Tapped hole for M8 cylinder stud in crankcase on ROTAX engines type 912 UL and 912 A, certified to JAR 22

Checking of the tapped hole ❶ in crankcase at cylinder no. 2.

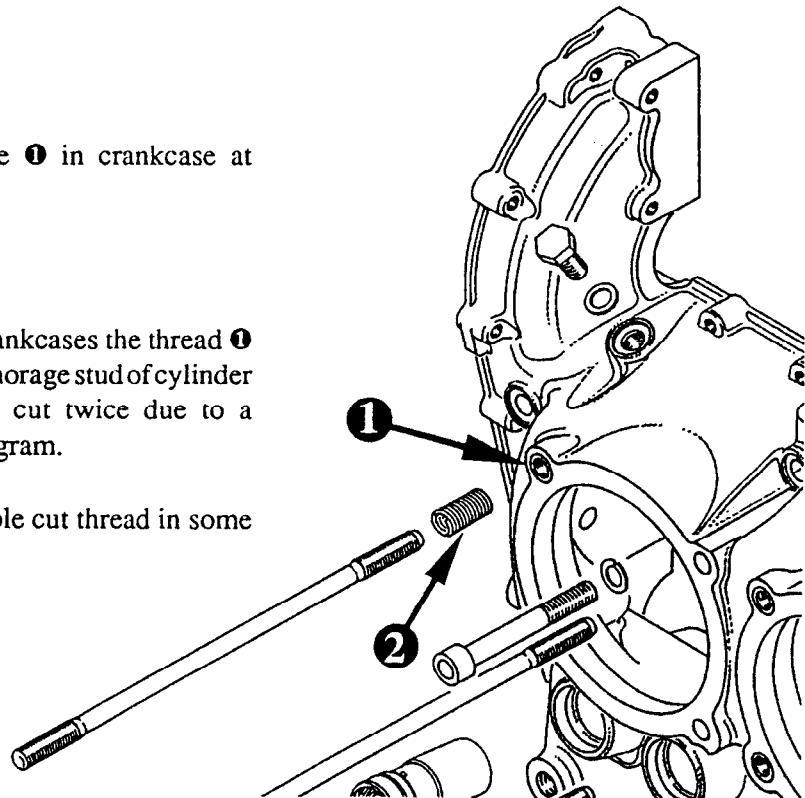
It was noticed that in some crankcases the thread ❶ for the helicoil insert ❷ for anchorage stud of cylinder and cylinder head had been cut twice due to a mistake in the machining program.

The result thereby was a double cut thread in some cases.

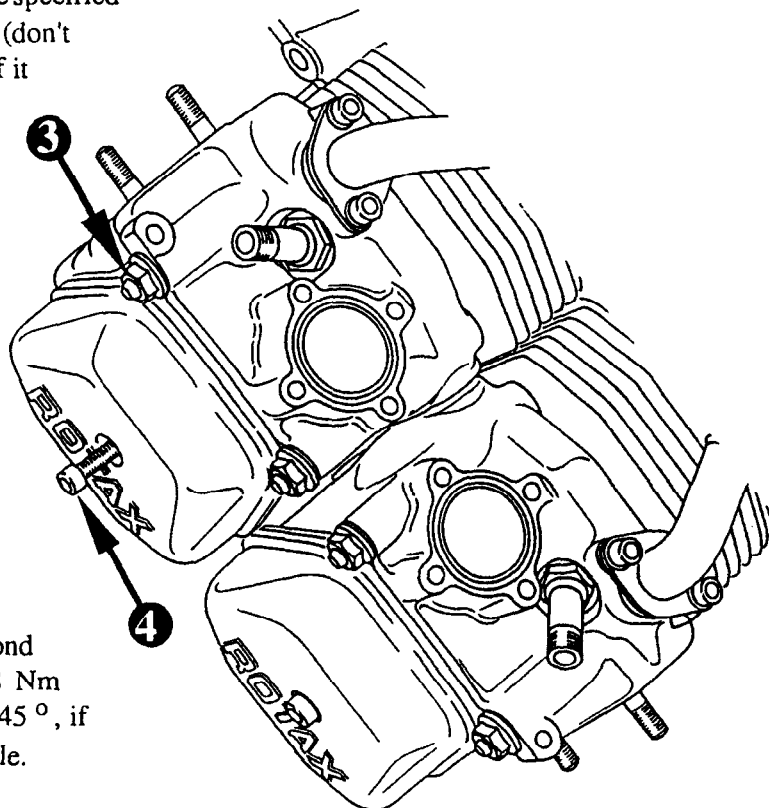
On an engine installed in an aircraft with at least three hours operating time tighten the hex. nut M8 ③ on cylinder 2 to the specified torque of 18 Nm = 160 in.lb. (don't loosen before tightening). If it needs 45 ° or more wrench movement for tightening the thread must be rectified.

If on the first check the needed turn was less than 45 ° a second check for safety shall be carried out after further 3 hours running time. The thread is o.k. if at the second check the tightening to 18 Nm (160 in.lb.) takes less than 45 °, if more, rework the tapped hole.

All **non certified** engines (912 UL) with faulty thread according to par. 5) can be rectified by an authorized dealer.

All **certified** engines (912 A) with threads declared faulty to par. 5) have to be shipped to ROTAX Austria.

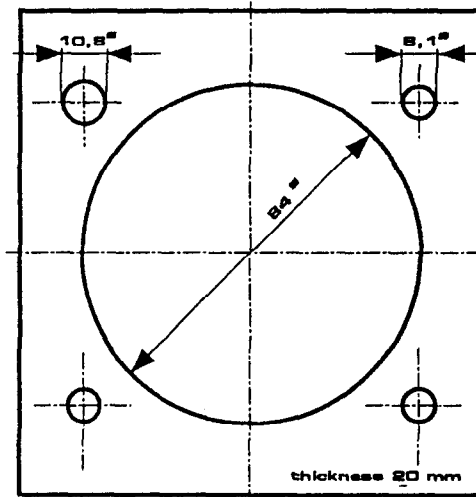
Remove Allen screw M6x25 ④ and take off valve cover and the two O-rings. Cross wise remove 2 hex. nuts along with washers and 2 cap nuts, carefully push off cylinder head assy. utilizing screw driver. The two oil return tubes and pushrods to remain with the head.

For removing the helicoil insert bend up the end of the helicoil using a pair of pointed pliers and turn out the helicoil insert. Fit the drilling template ⑤ to crankcase (provided by ROTAX) using suitable distance tubes and bore into faulty tapped hole using 10,8 Ø drill, 23 mm (0,9 in.) deep from crankcase sealing face.

drilling tamplate ⑤

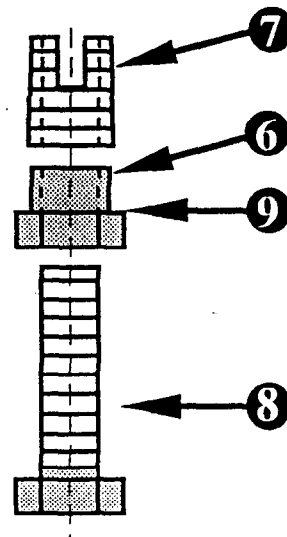
Fit and lock shoulder nut ⑥ against thread insert ⑦ on hex. screw M8x30 ⑧ (grade 10.9, highstrength).

Fit unit into 10,8 Ø bore by screwing-in (cutting process) until shoulder of nut ⑨ stops at sealing face of crankcase, thus the thread insert ⑦ is recessed by 5 mm (0,2 in.). Take care at screwing-in process to keep centre line square to sealing face of crankcase. Remove hex. screw M8x30 and shoulder nut after slackening shoulder nut from thread insert.

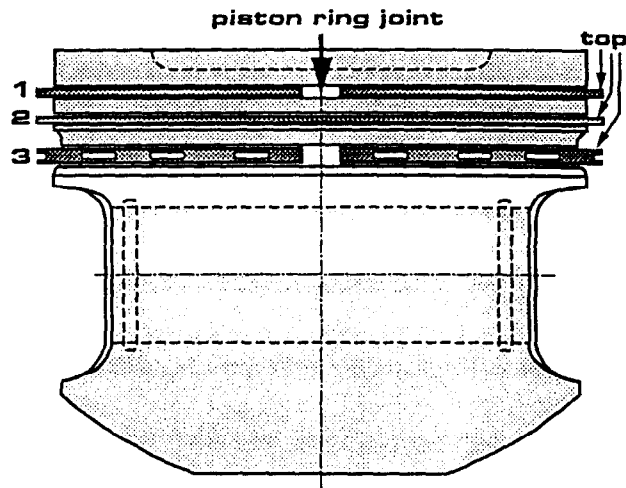
Oil cylinder and place new O-ring 87x2 on collar of cylinder. Take care of proper staggering of the piston ring gaps.

Position gap of 1st and 3rd piston ring on centre of piston skirt and stagger 2nd ring 180°. Never position rings with gap in the vicinity of piston pin boss. Oil piston, apply piston ring clamp and carefully fit cylinder over piston in position.
